REMARKS

ANNOTATED MARKED-UP DRAWING

Fig. 1
PRIOR ART

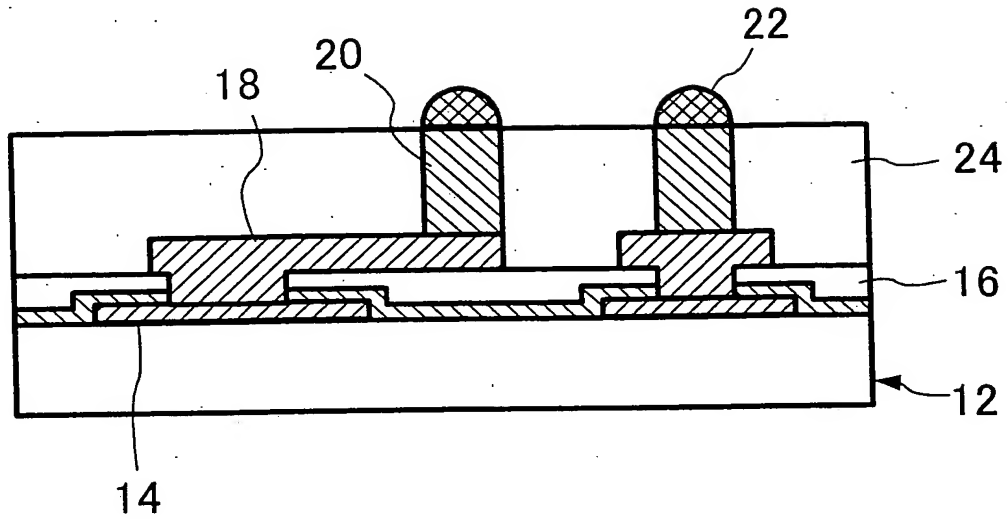
In prior art Fig. 1 of the present application, metal pad 14 and molding resin 24 are shown. It should be understood that the connecting portions 240, 340, 440 and 540 as respectively illustrated in Figs. 5, 6, 7 and 9 are incorporated into the semiconductor package as illustrated in Figs. 1 and 2. Accordingly, all features of the claims are illustrated in the figures as taken together. Applicant therefore respectfully submits that the drawings are in compliance with 37 C.F.R. 1.83(a), and thus respectfully urges the Examiner to withdraw this objection for at least these reasons.

Responsive to the Examiner's requirement, the drawings have been corrected as indicated in red ink in the attached annotated marked-up drawings, whereby Figs. 1-4 have been denoted as "PRIOR ART". Also, the conductive post in Fig. 3 has been denoted by reference numeral 20, as described in paragraph [0018] of the present application. The above noted drawing corrections have been incorporated into the
